# Providence City Plan Commission

June 16, 2020

## AGENDA ITEM 2 - 209-217 ANGELL STREET

**20-010 UDR**  
Land Development Project  
Master Plan / Unified  
Development Review

First floor plan

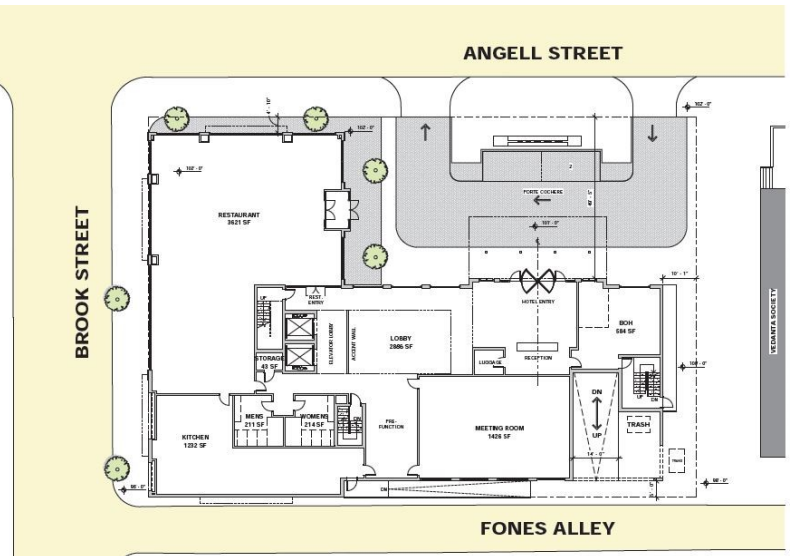
A design waiver is requested as a large portion of the front façade will be located beyond the five foot build-to zone, behind the driveway and a landscaped area. Based on the submitted plan, it appears that the waiver is being requested to provide access to the site from Angell Street, which is one way. Vehicles will enter from the eastern approach and exit from the west. The DPD is not opposed to granting the waiver as it appears to be necessary to accommodate site access. A landscaped area will be provided to address the street frontage.

The CPC should grant the design waiver for a portion of the building to be located outside the build-to zone on Angell Street. The waiver is contingent on the applicant successfully receiving a zoning change for the property to C-2.
